La Jolla Shores Planned District Advisory Board (LJSPDAB) APPLICANT PROJECT INFORMATION FORM

Subject: 8081 Calle Del Cielo, Assessment Letter; Project No. PRJ-1104216
Internal Order/Trust Account: IO: 24009698. La Jolla Community Planning
Association.

Site Development Plans, Akavan Residence, 8081 Calle Del Cielo San Diego, CA 92037, dated July 25, 2024

Site Development Plans PRJ-1104216.pdf

SHEET TITLE: **PROPOSED EXTERIOR ELEVATIONS**

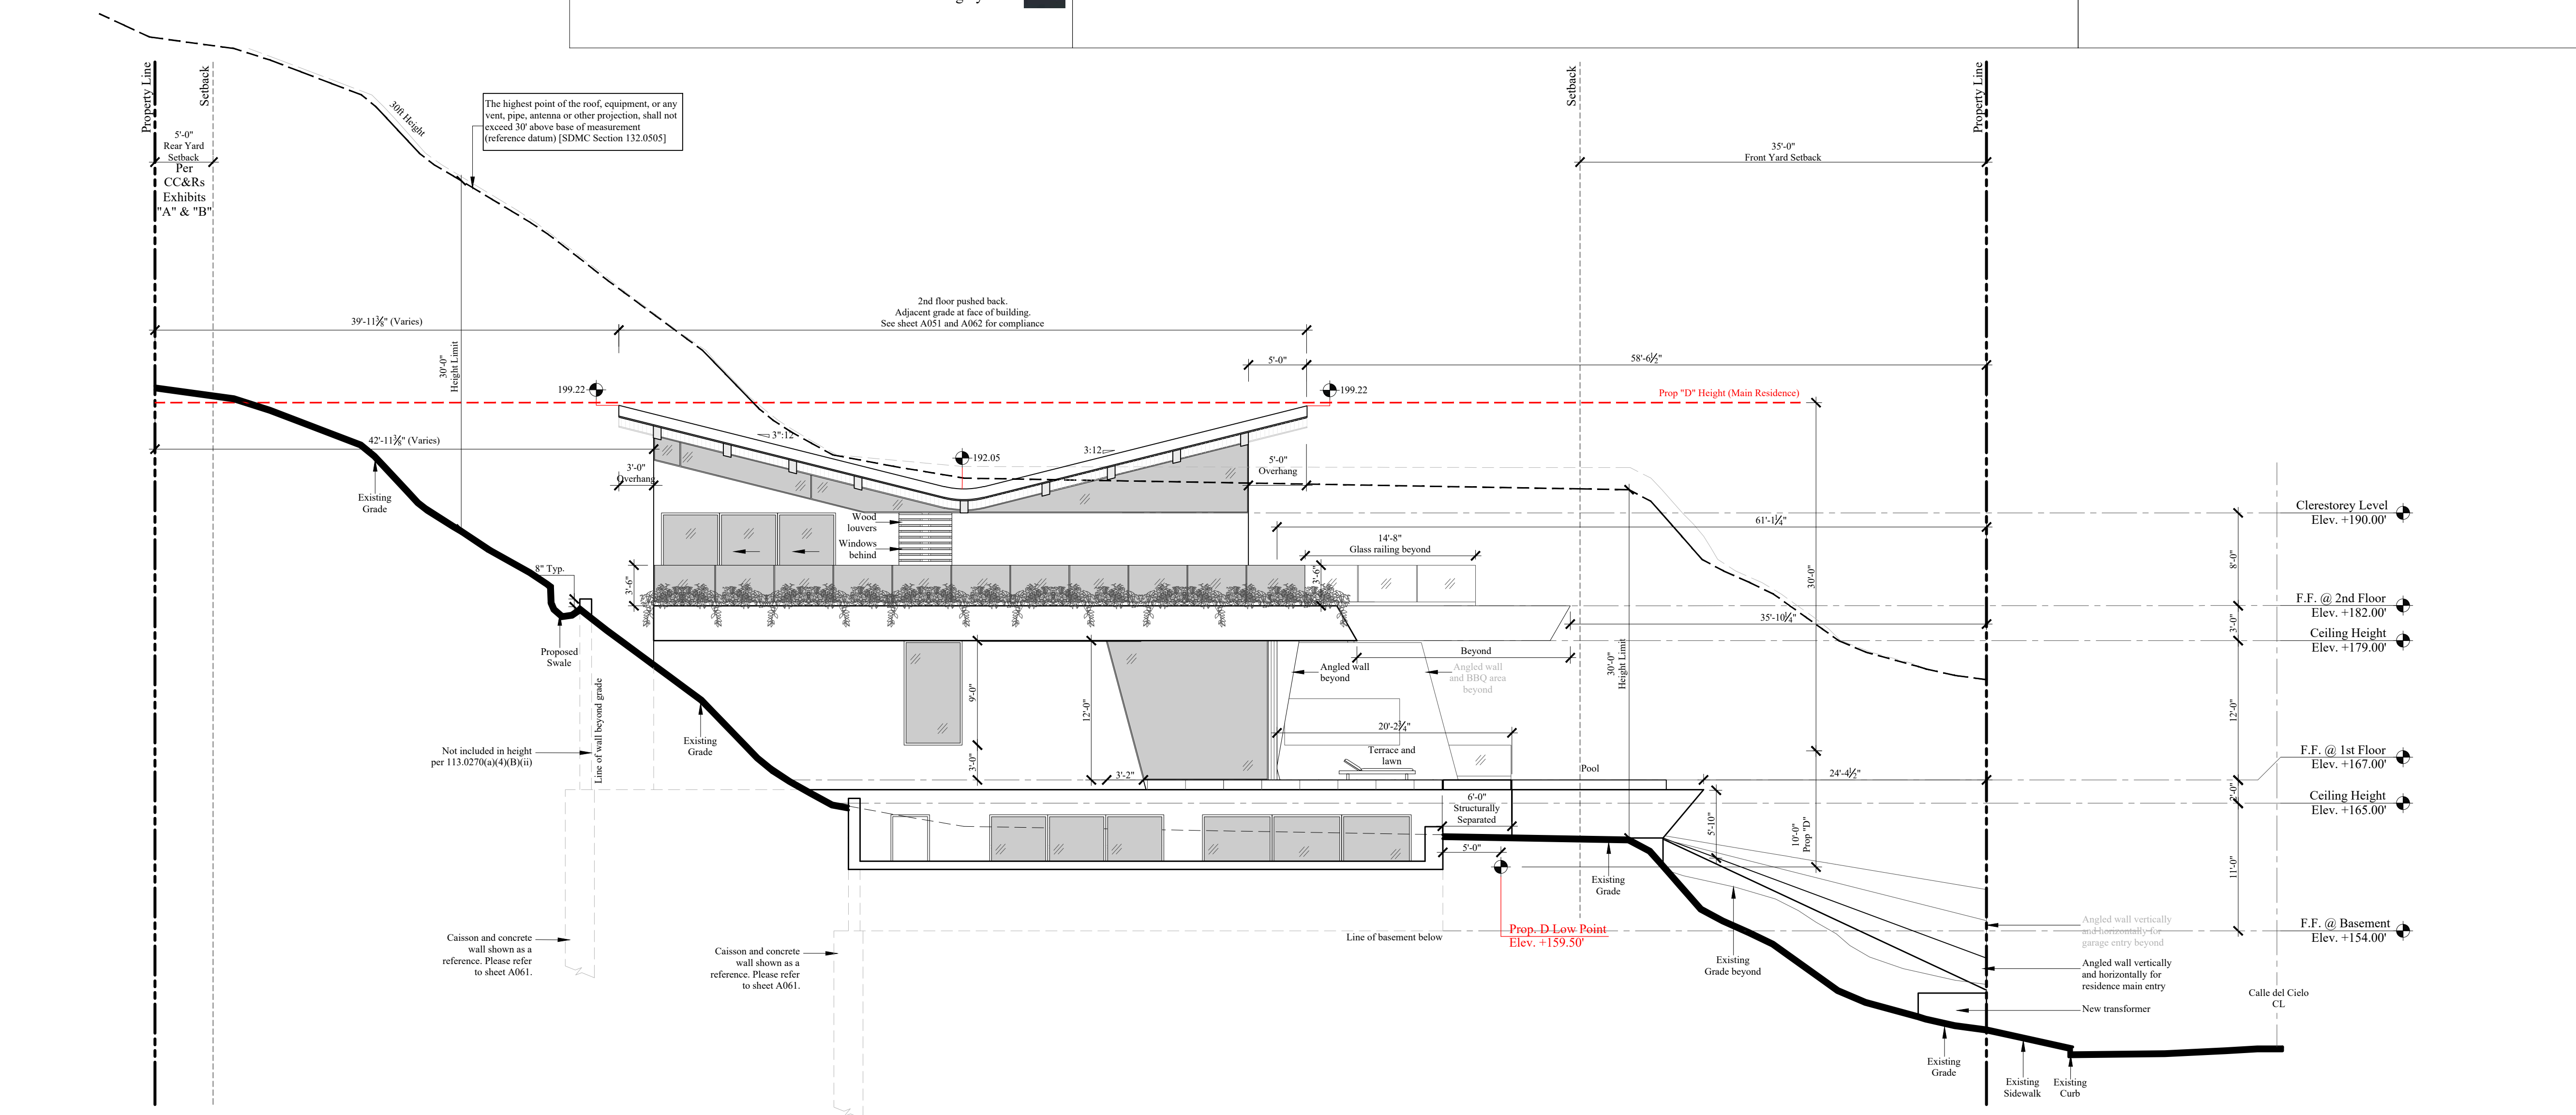
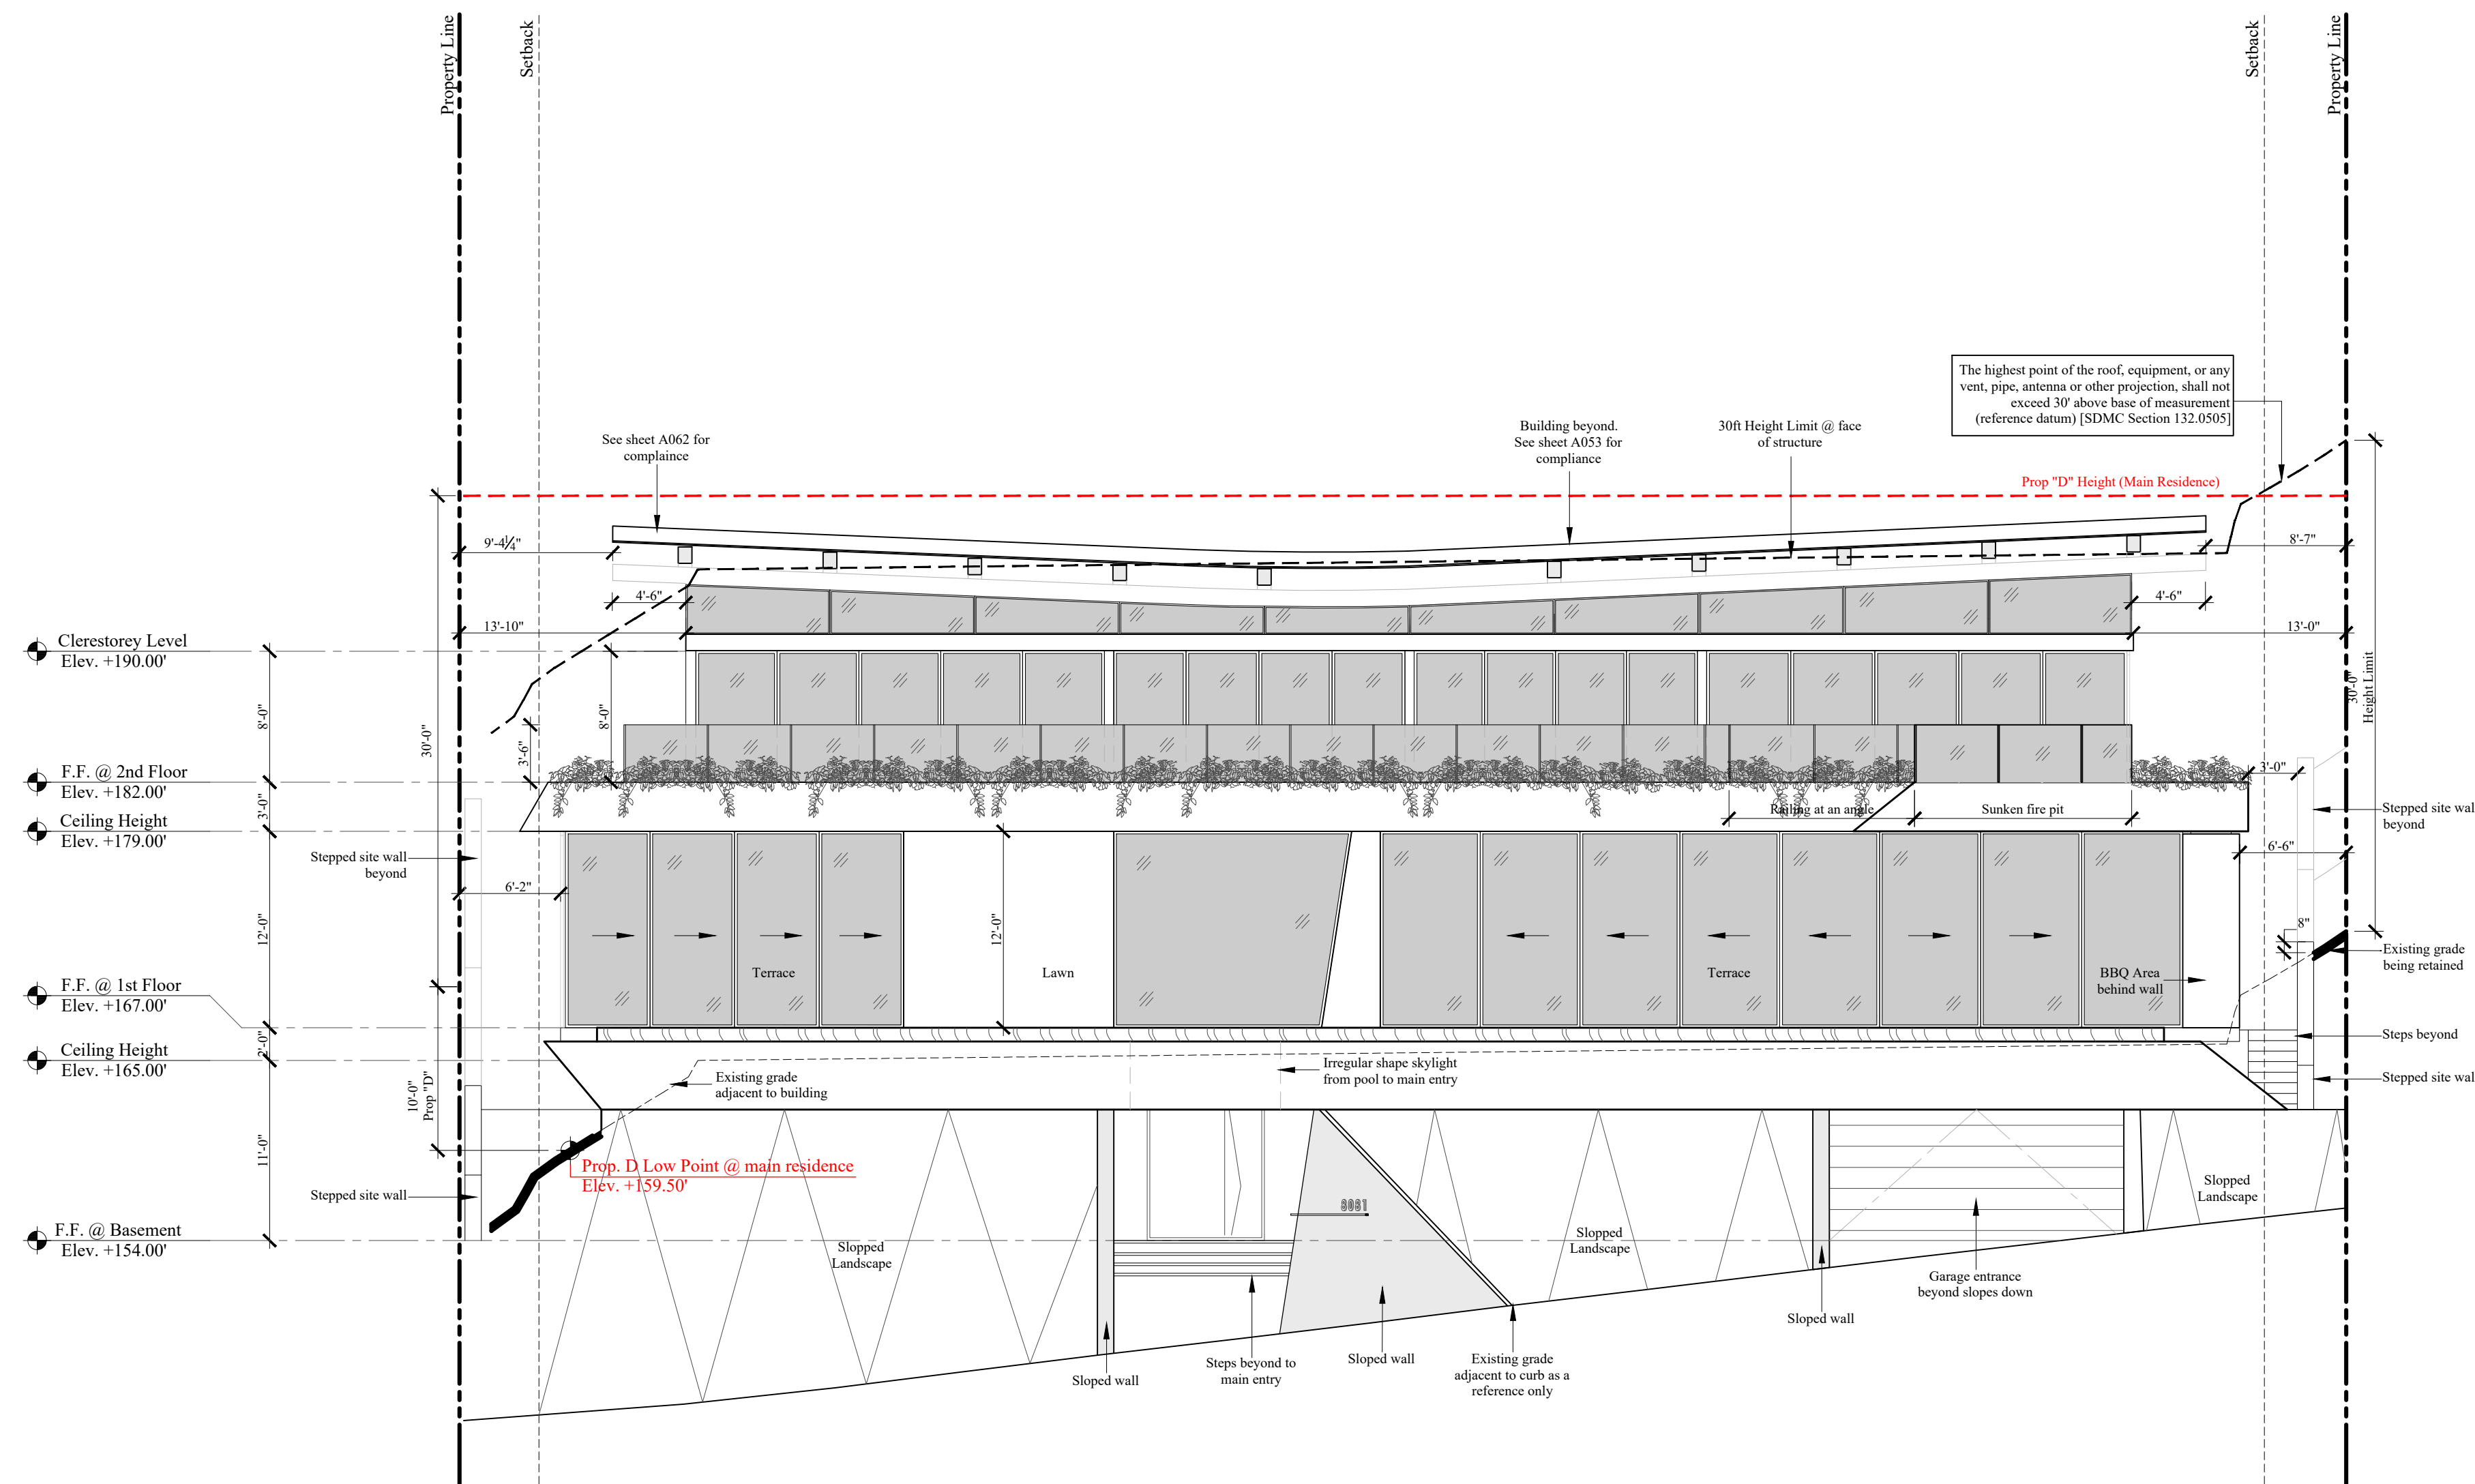
Please show existing and proposed grade on all elevations.

Plumb line height appears to be projected from the incorrect elevation point . Please revise to show 30 foot projection at the terrace level taken from adjacent grade, existing or proposed, whichever is lower.
